1984 Corvette: Service Bulletin: Engine Stops Running When Starting with Air Conditioning "On"

Subject: Engine Stops Running When Starting with Air Conditioning "On"
Model and Year: 1984 Corvette with Automatic Transmissions
Source: Chevrolet Dealer Service Bulletin
Bulletin No: 84-240
Section: 8B (XII)
Date: Feb. 1985

**A/C CLUTCH ON REVISED ECM SIGNAL
INPUT BLOCK DIAGRAM**

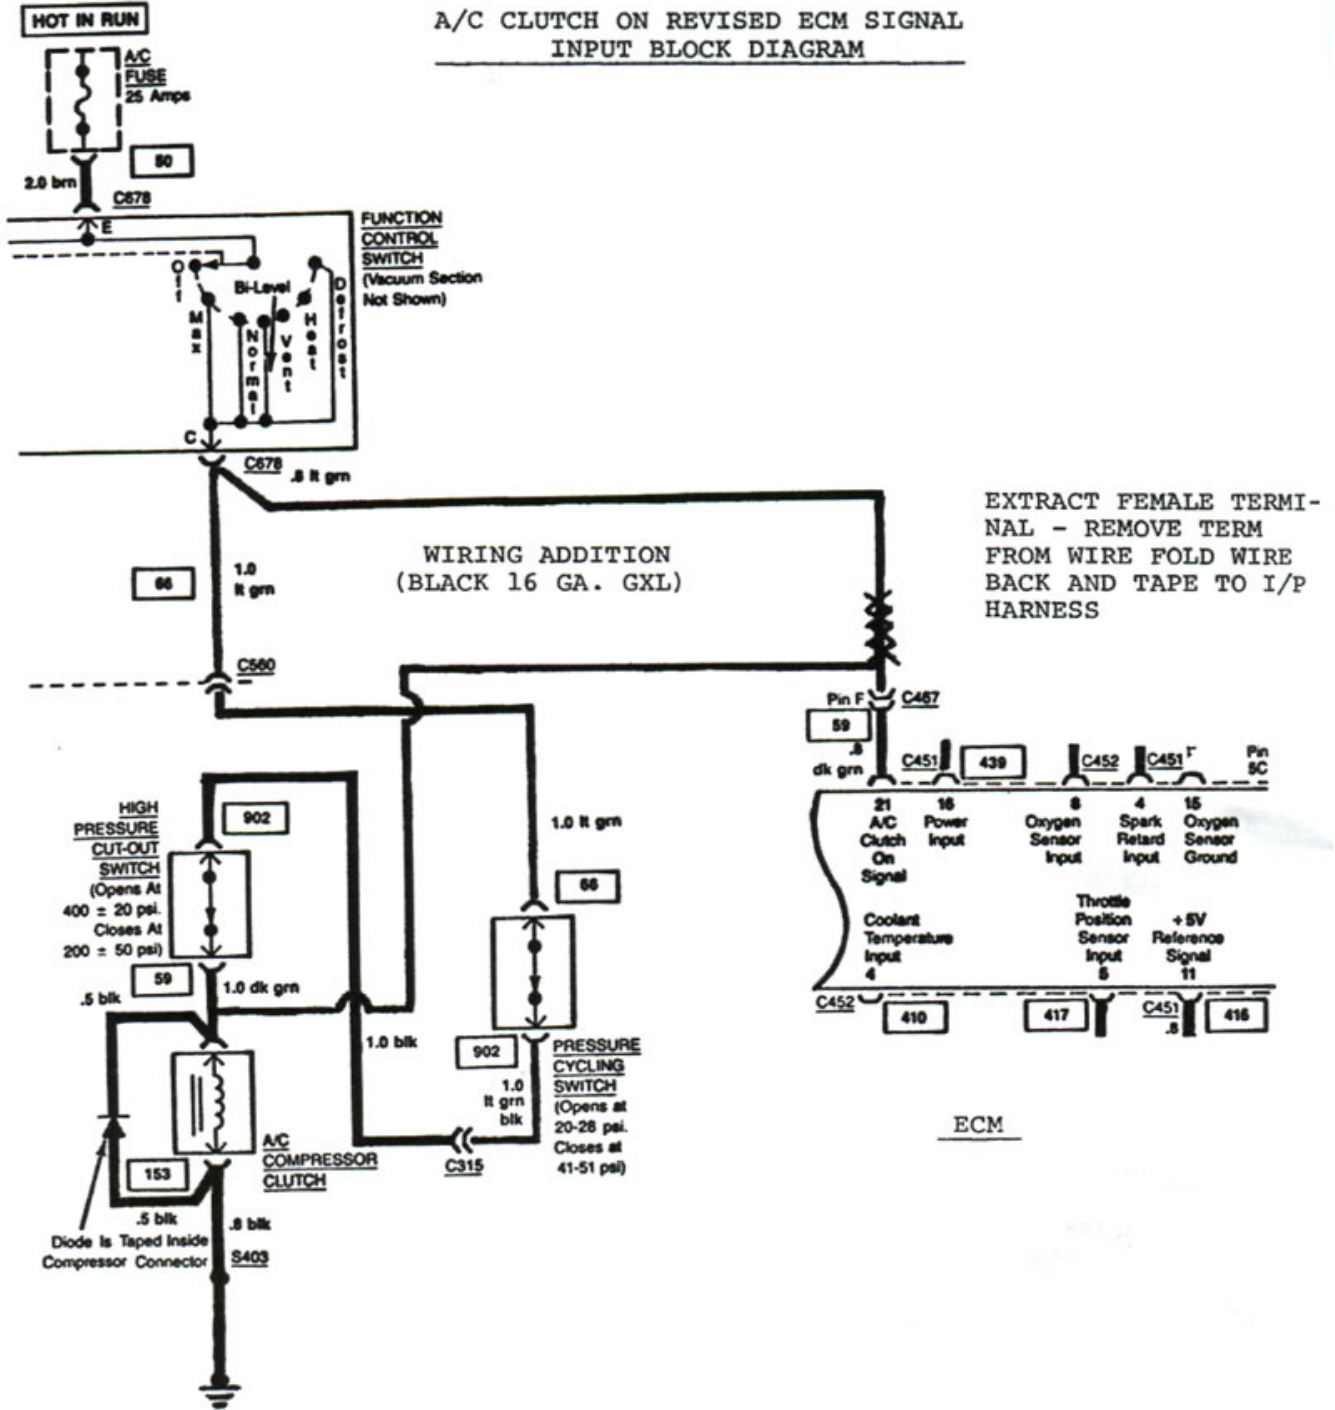
This revision requires installing a 16 Ga. wire into the A/C discrete circuit at connector C-467, Pin F of the I/P to ECM harness, routing the wire through the bulk head connector and splicing into the A/C circuit of the engine, between the pressure cycling switch and the compressor clutch (see block diagram).

FIGURE 1

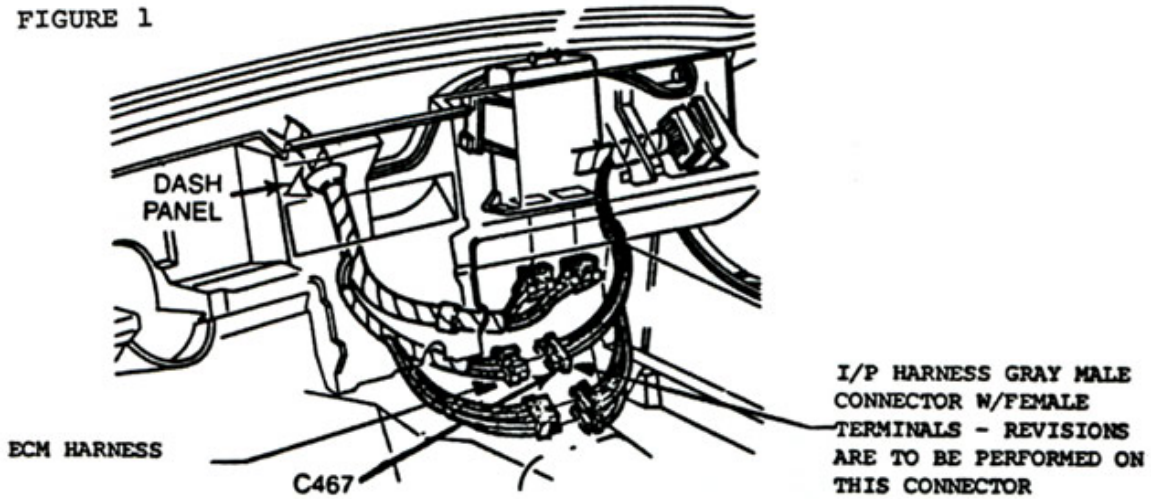
1. Remove I/P upper trim pad assembly. Remove L.H. and R.H. hush panels.
2. Extract female terminal (green wire) from gray I/P to ECM harness connector C-467, circuit 66 (see Figure 1.)
3. Cut off and discard extracted female terminal. Fold severed green wire back and tape it to the I/P harness, making sure the severed wire end is well insulated with electrical tape.
4. Utilize the 22 feet of 16 Ga. GXL black wire by stripping one end and crimping, P/N 12015856, female terminal on the stripped end. Insert the new terminal into connector C-467, Pin F.

FIGURE 2

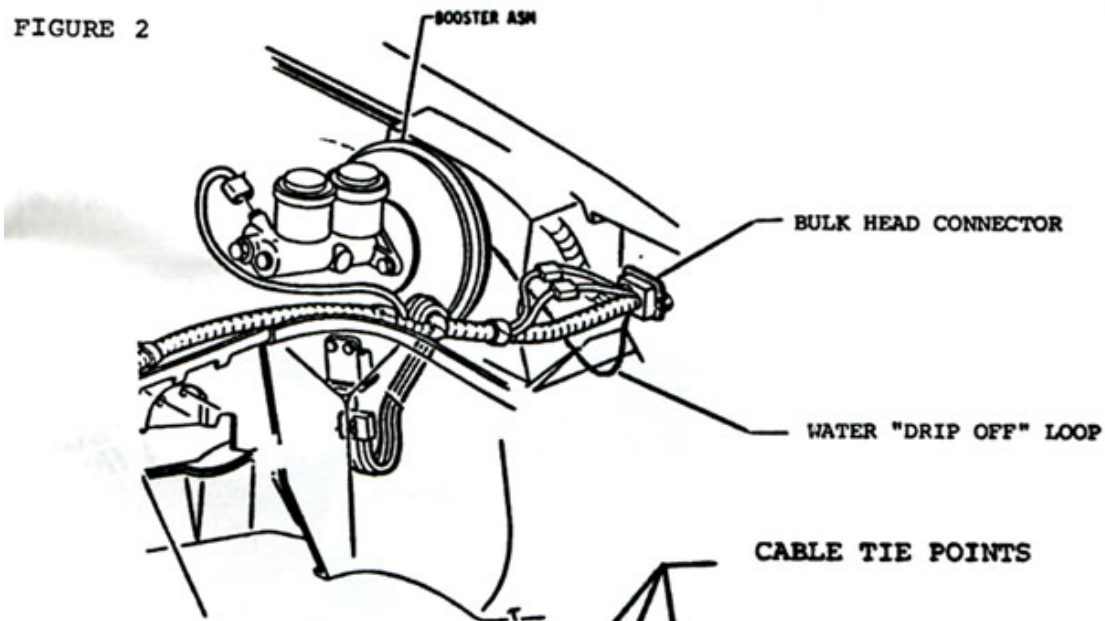
5. Route 16 Ga. signal wire up and across the top of the A/C ducts and under the aluminum dash braces. Feed the wire down the L.H. forward side of the I/P panel adjacent the fog lamp switch.

6. Using masking tape, secure the signal wire to the A/C ducts to avoid wire abrasion and rattles.
7. Remove I/P harness bulk head caps on the passenger compartment side, as well as the engine compartment side. DO NOT disconnect the bulk head connectors.
8. Feed the signal wire through the open (unused) bulk head, Pin #E4, located adjacent to a 12 Ga. red wire. it may be necessary to strip the feed end of the signal wire approximately two (2) inches from the end and "solder tint" the wire to aid in guiding the wire through the bulk

FIGURE 3

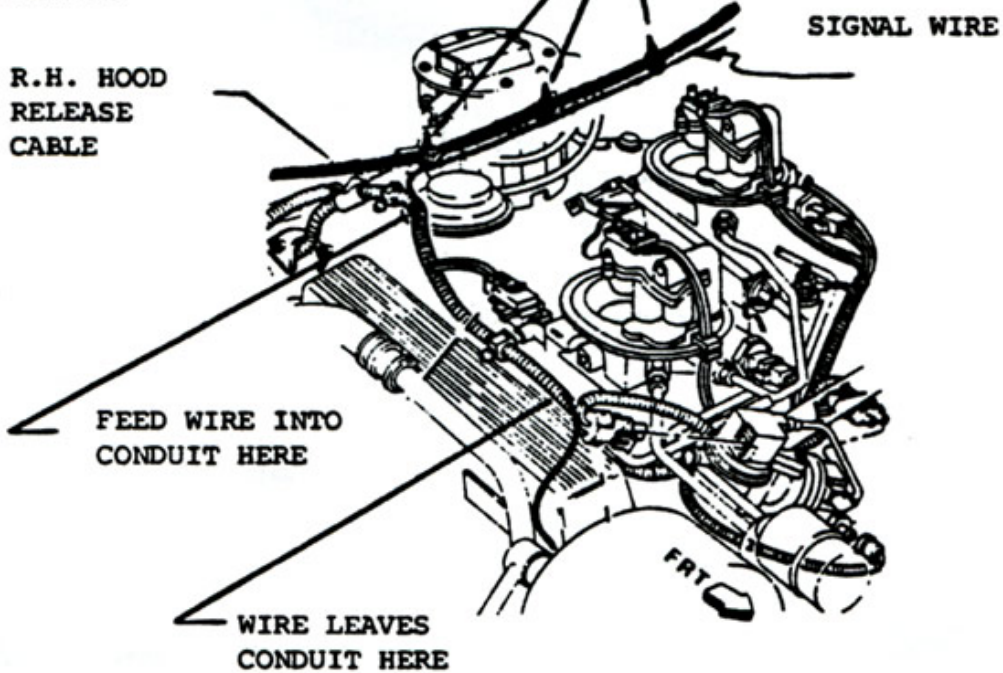
9. Once the signal wire has been fed through the bulk head connector, grease is to be packed around the signal wire at both sides of the connector. This step assures an adequate bulk head connector to signal wire seal.
10. Reinstall the bulk head harness caps.
11. Loop the signal wire down below the bulk head connector and back up behind the brake booster (see Figure 2.)
12. Route the signal wire along the R.H. hood release cable securing the wire to the cable with three (3) cable ties.
13. At the R.H. rear corner of the engine, direct the wire to the front of the engine and install it in the existing engine harness conduit (see Figure 3.)

FIGURE 4

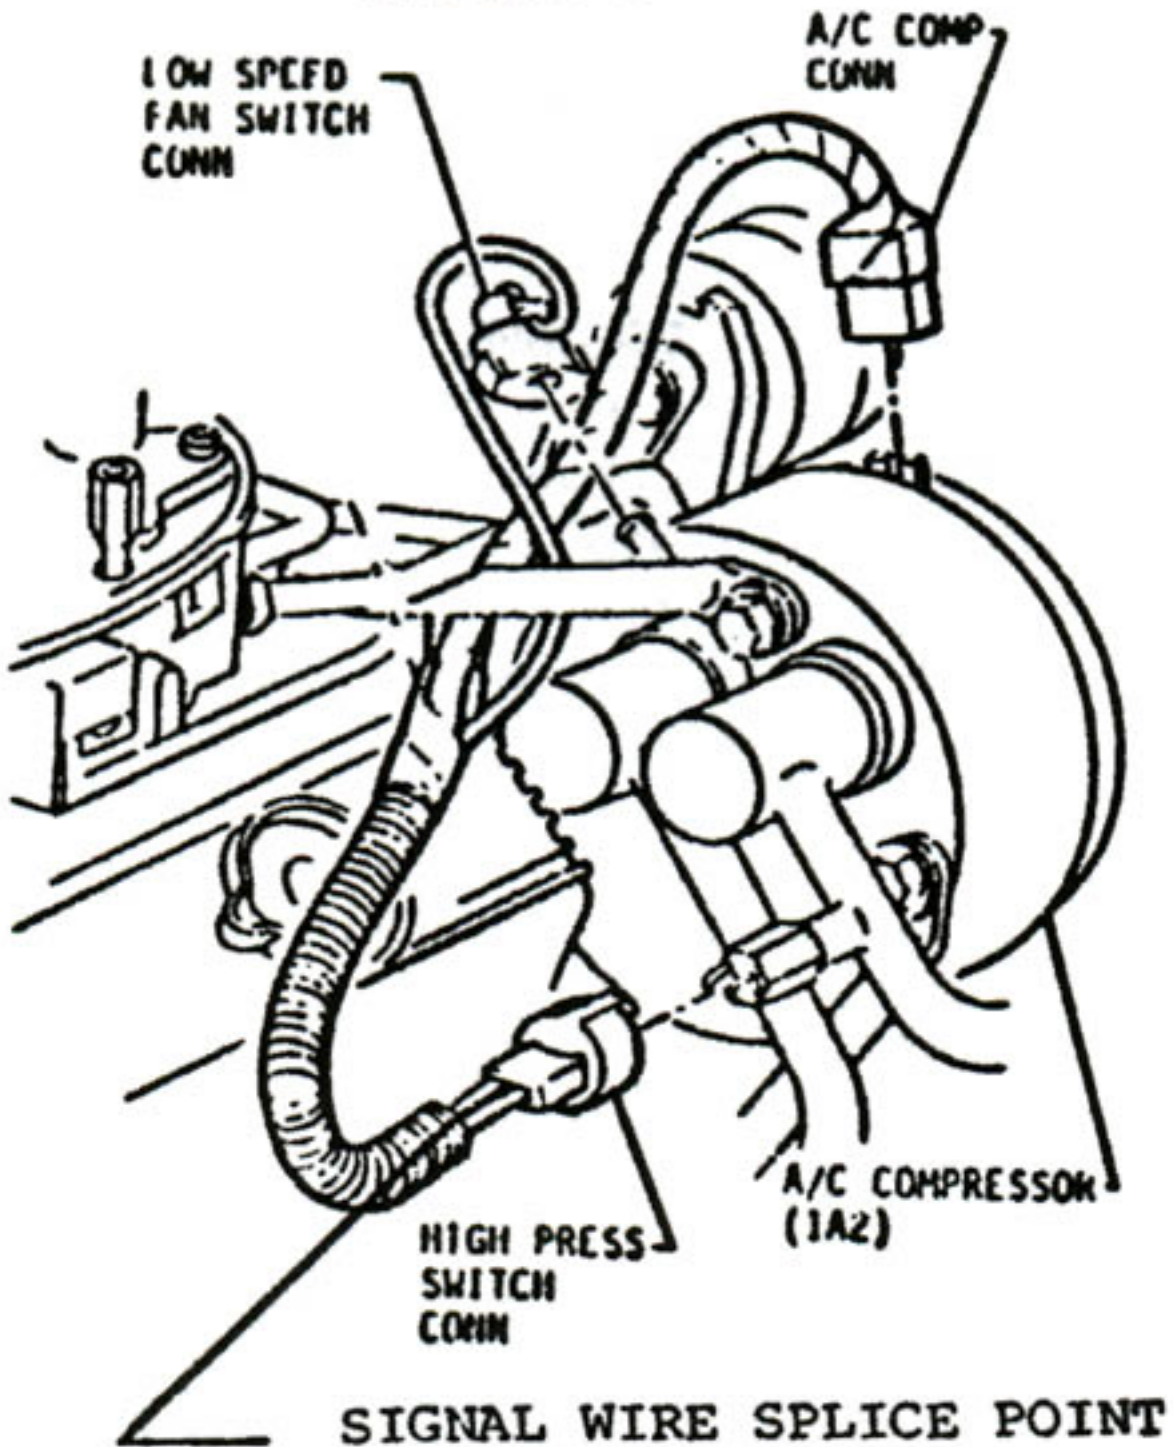
14. Remove the harness end tape and strip the insulation back .5 inches on the green wire at the high pressure A/C switch connector (see Figure 4.)
15. Remove excess signal wire length, if necessary, and strip end back .75 inches. Wrap the signal wire around the A/C clutch green wire and solder to insure a good connection.
16. Retape harness at high pressure switch connector.
17. Reinstall I/P upper trim panel and hush panels.
